TOWN OF RIDGWAY
BEAVER CREEK INFILTRATION GALLERY
ADDENDUM NO. 2
April 24, 2026

The following changes, additions, and/or deletions and clarification are hereby made part of the CONTRACT DOCUMENTS FOR BEAVER CREEK INFILTRATION GALLERY. This ADDENDUM NO. 2 takes precedence over the original Contract Documents as noted. Except as presented herein, all other conditions of the contract remain as presented in the original Contract Documents.

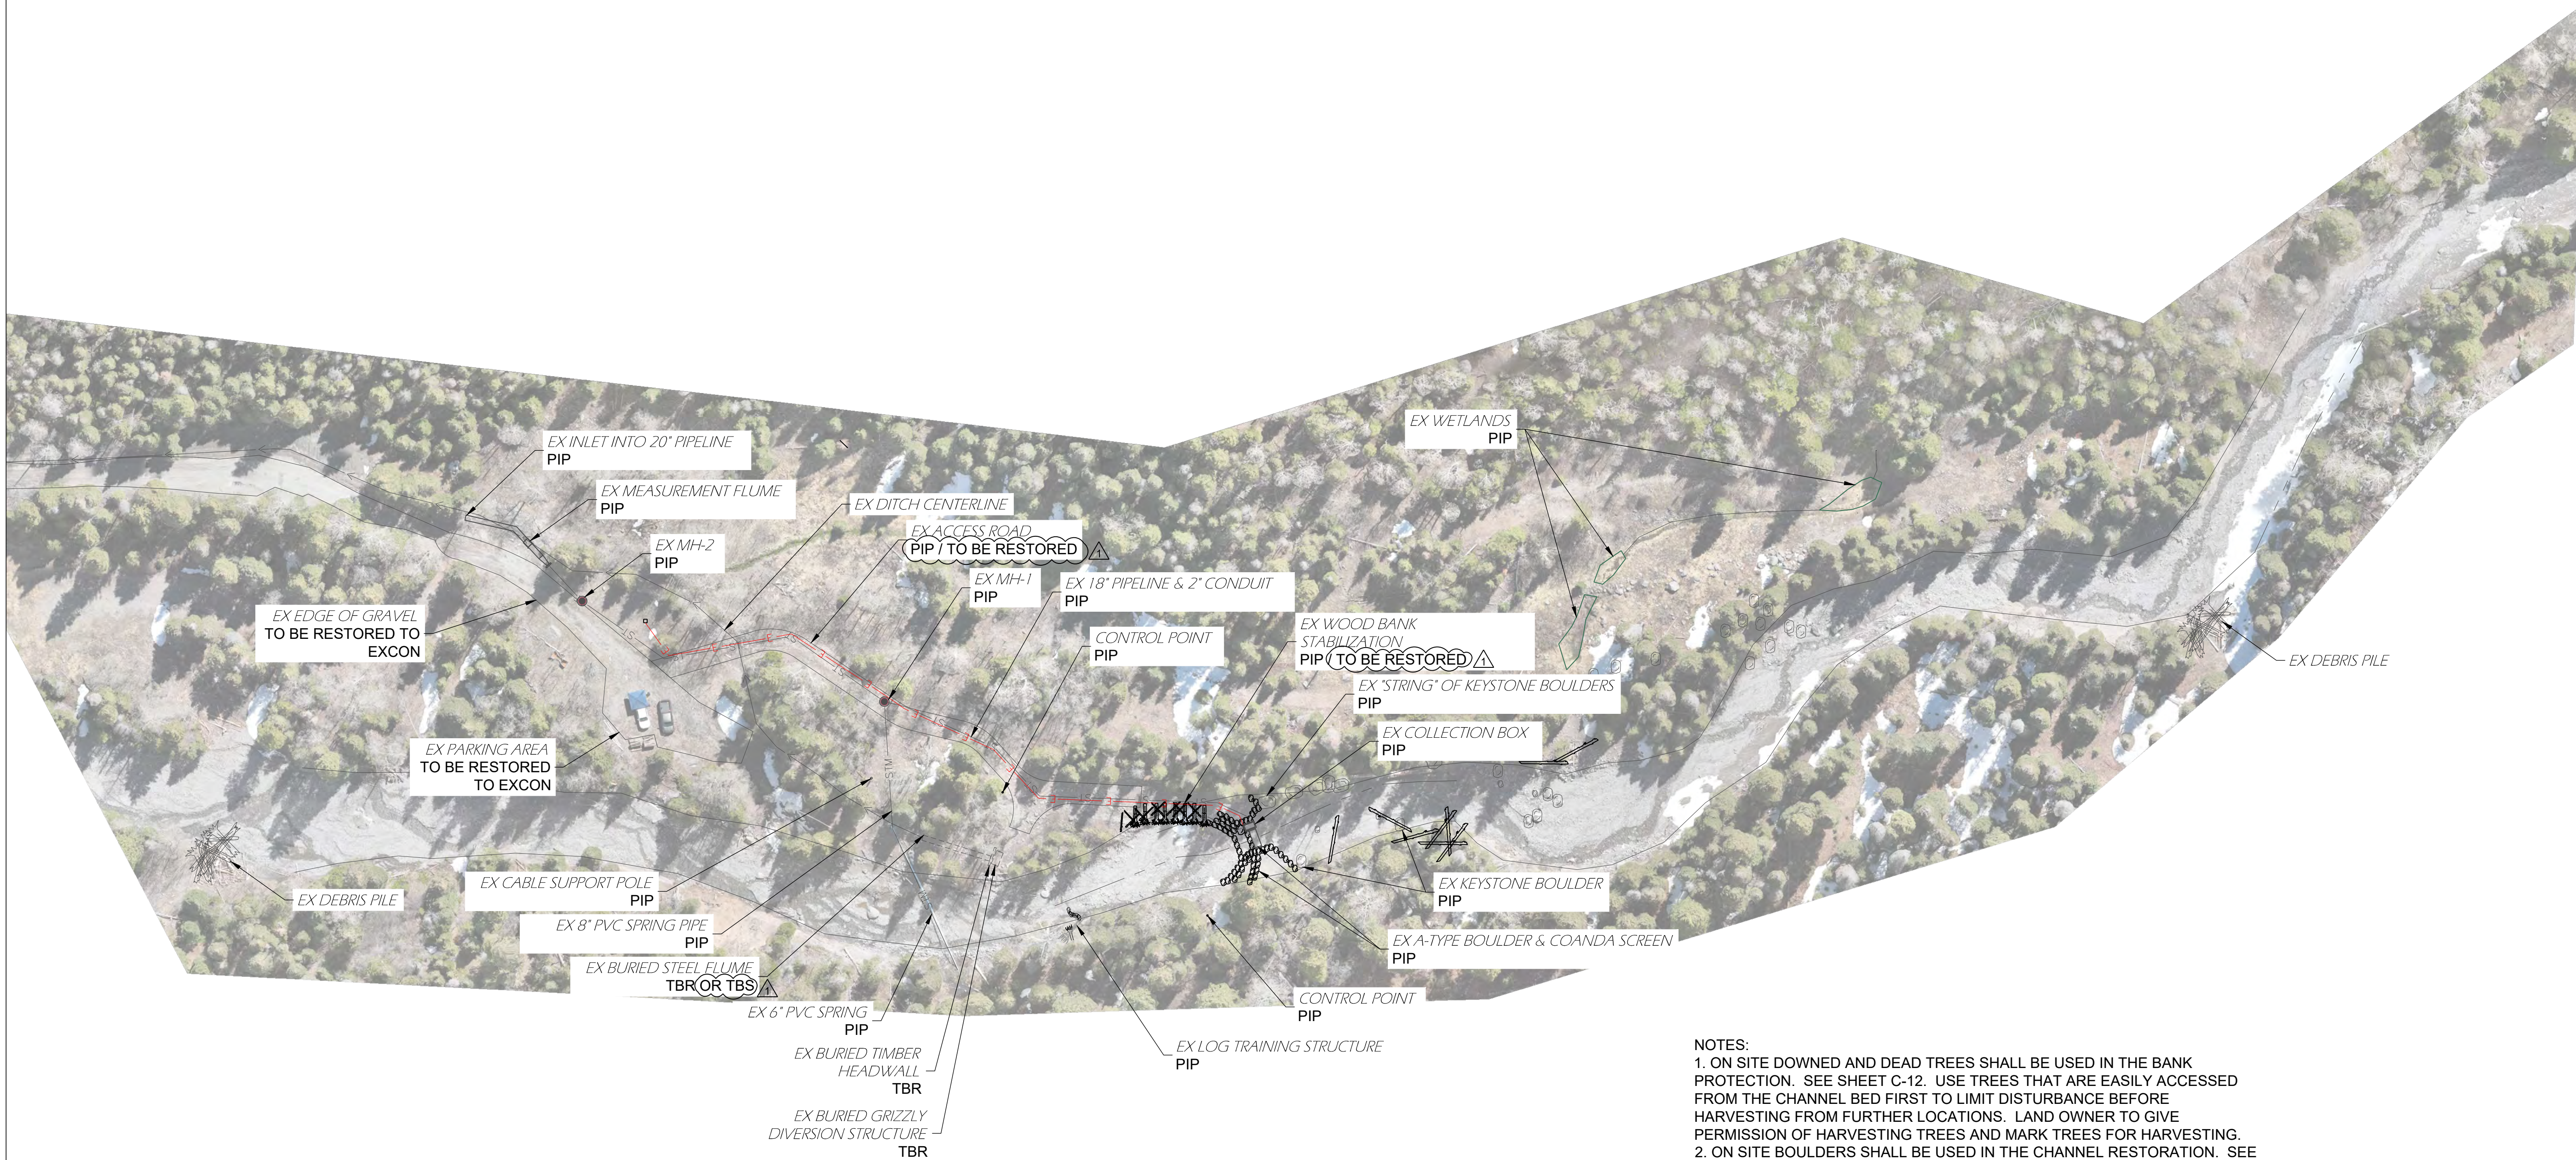
Response: The negative earthwork value in Bid Alternate B is to zero out line item 9 Earthwork, Excavation and Fill On-Site. Bid Alternate B is in case some of the excess material needs to be hauled off-site rather than be spoiled onsite. Limits of disturbance have been modified to include onsite spoil location, see attached sheets.

Response: The limits have been adjusted in the attached plans.

4X4 ACCESS RAMP DETAIL

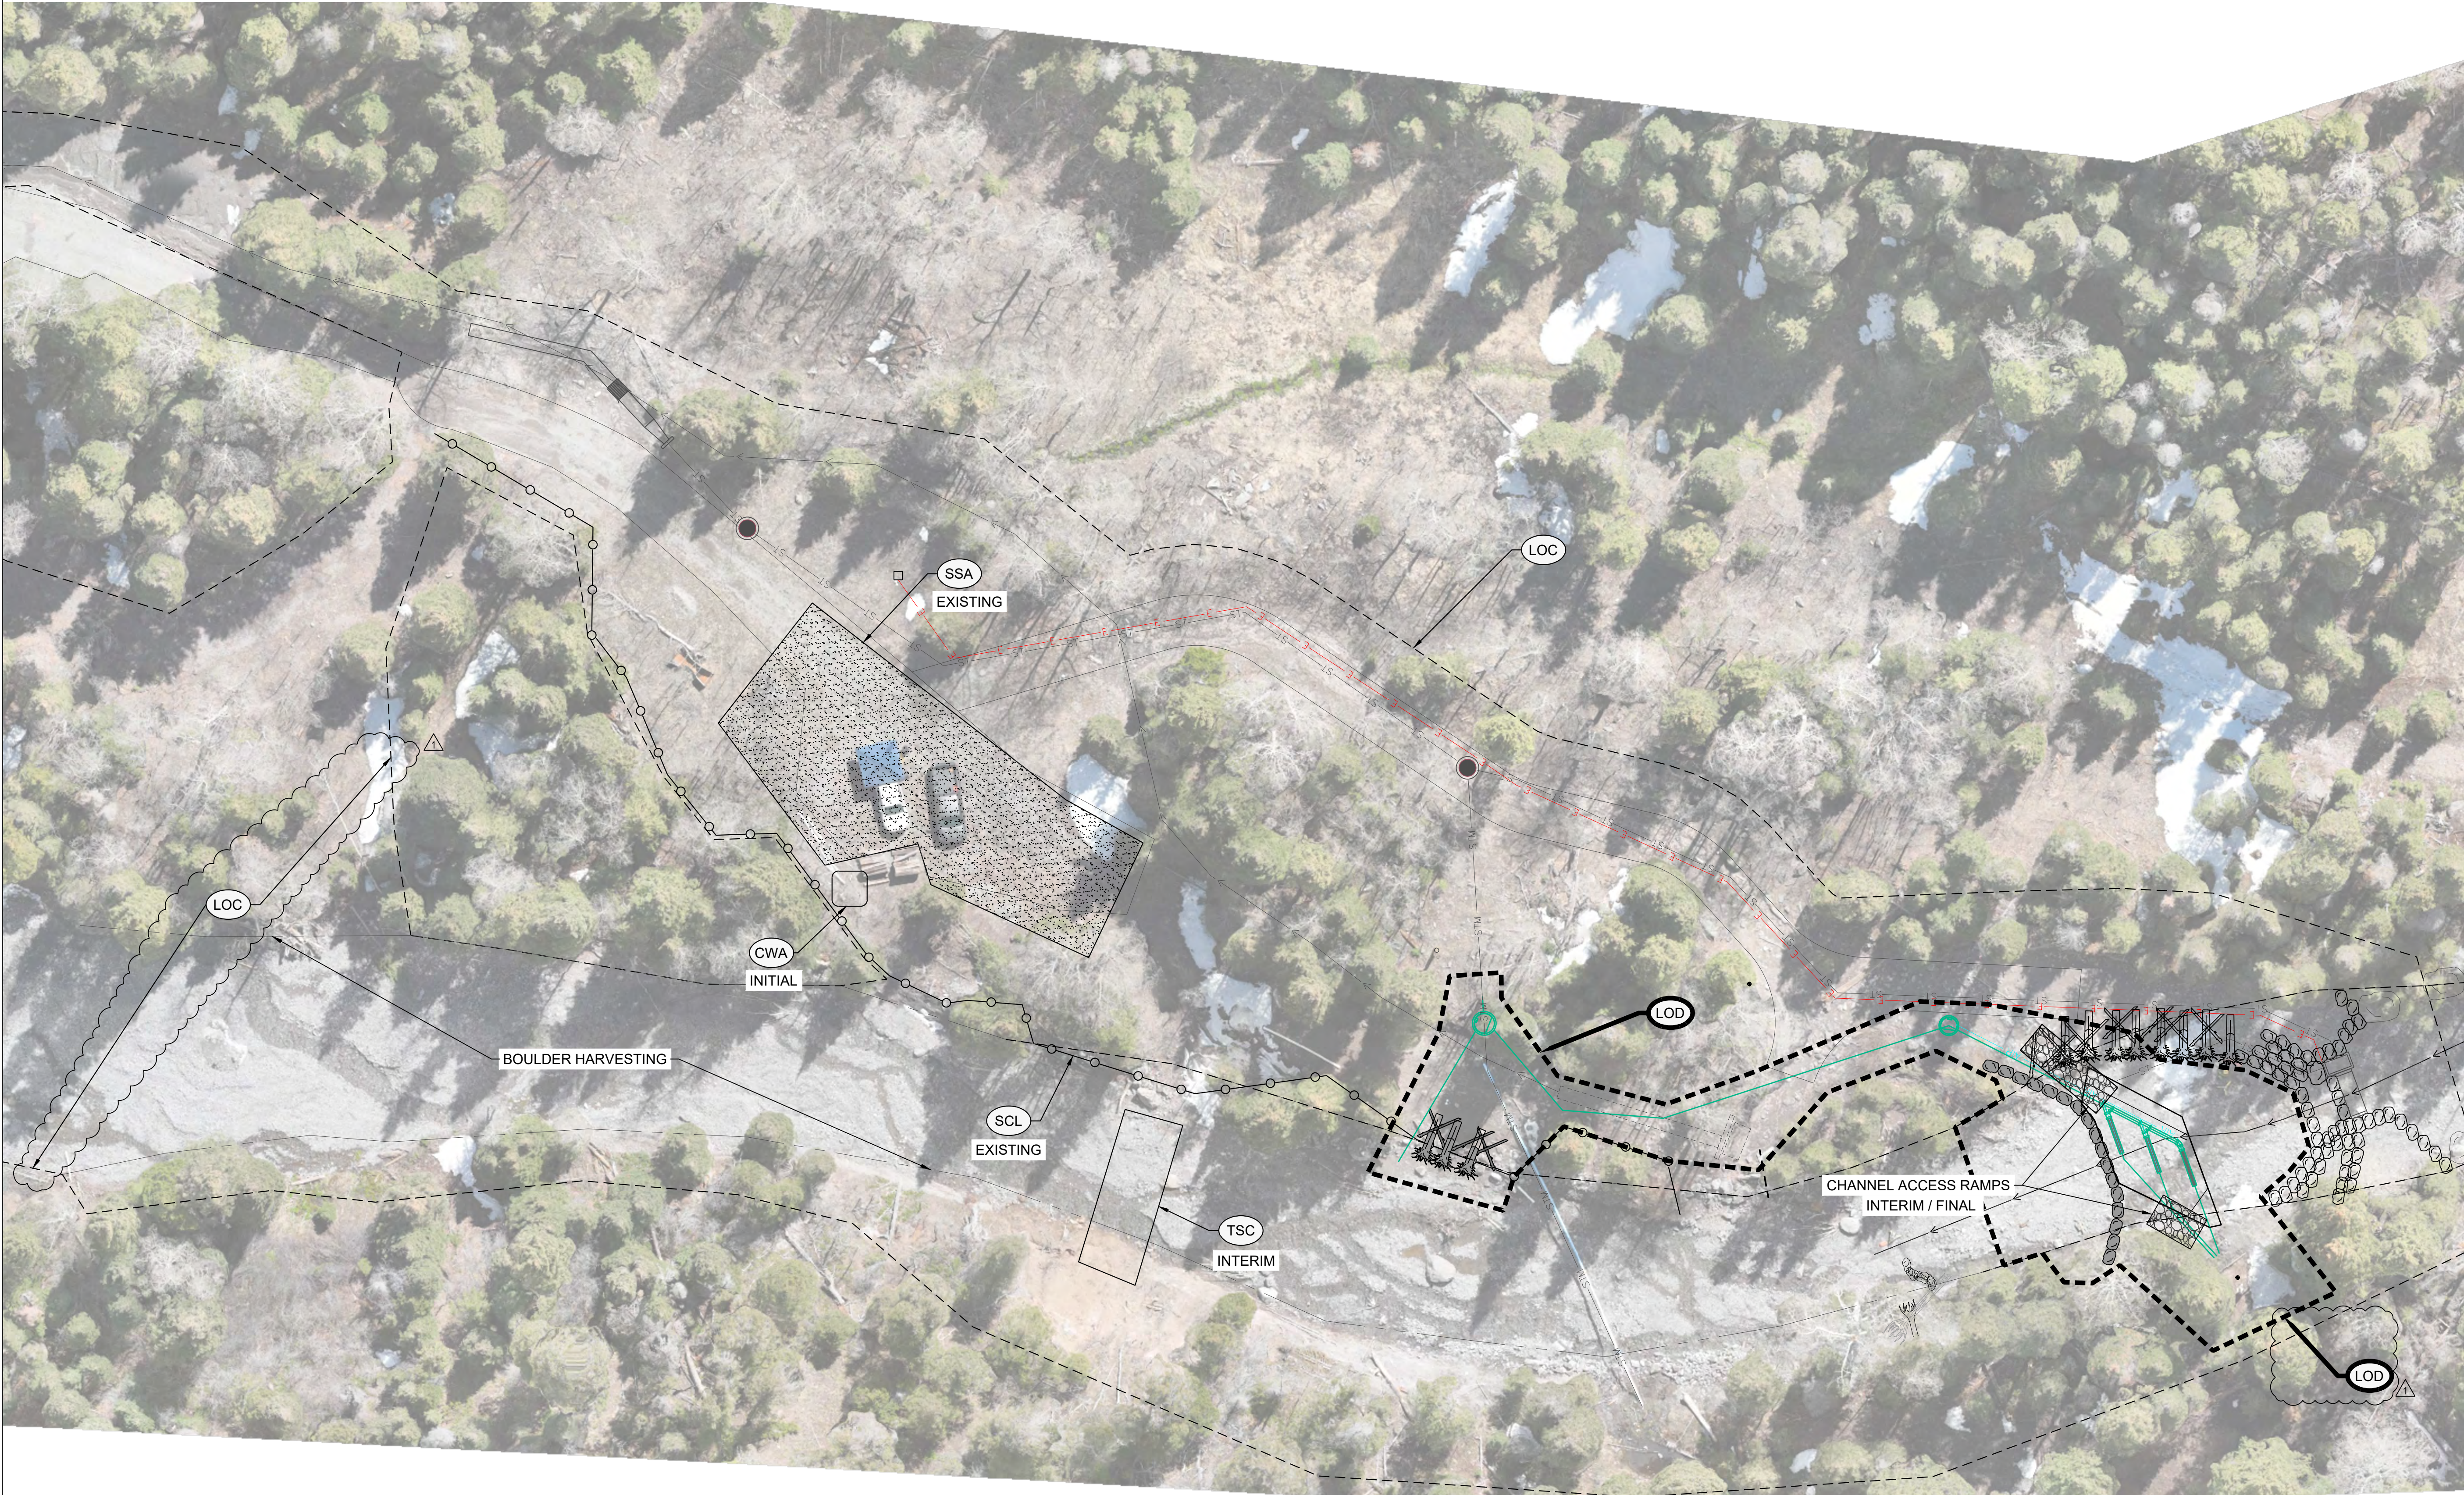
Response: The plans attached to this addendum include a 4x4 access across to the west bank for access to the water jet the infiltration gallery. There are dead and downed trees on the west bank that can be salvaged for the bank stabilization.
